Subject: MHI's Revised Response to US-APWR DCD RAI No. 111-932 Revision 0

**Response to Request for Additional Information
No. 111-932 Revision 0**

**US-APWR Design Certification
Mitsubishi Heavy Industries
Docket No.52-021**

RAI NO.: NO.111-932 REVISION 0
SRP SECTION: 06.02.01.02 – Subcompartment Analysis
APPLICATION SECTION: MUAP-07031 Report
DATE OF RAI ISSUE: 12/3/2008

Figure 1 Time step sensitivity analysis for reactor cavity compartment
Pressure transient at peak pressure node (V50)

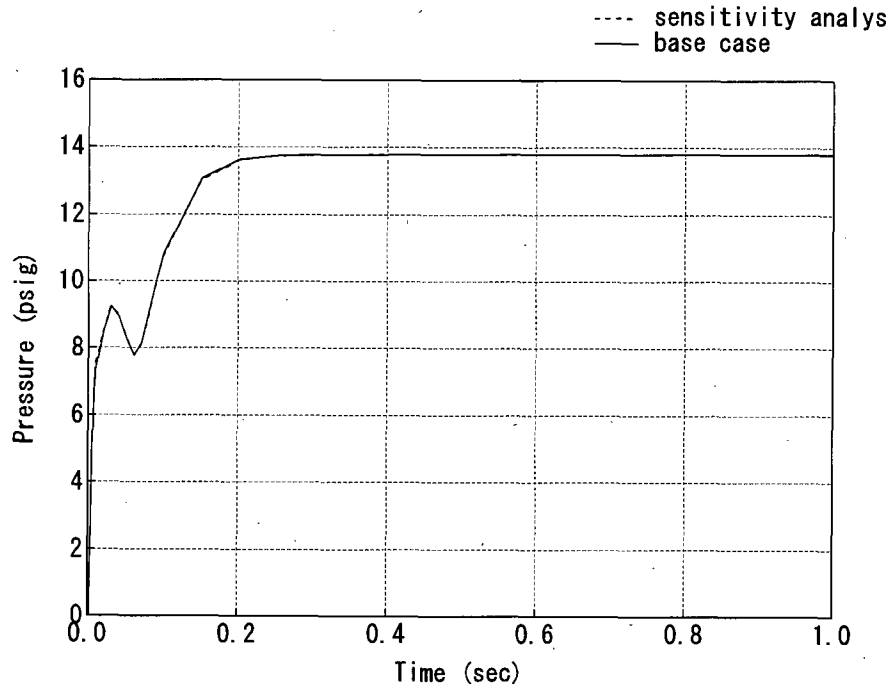
MUAP-07031 report: Although sensitivity of the results to time step variation in the cases presented was small, many variables impact correct time step selection. Please, include in the DCD additional justification and/or discussion regarding the selection of the time steps for the specific limiting cases presented in the DCD.

The results of the sensitivity analysis compared with the base case for each subcompartment analysis are shown in Figure 1 to 3. The impact of the time step selection to the result is sufficiently small. It was confirmed that the appropriate time step was selected for US-APWR subcompartment analyses.
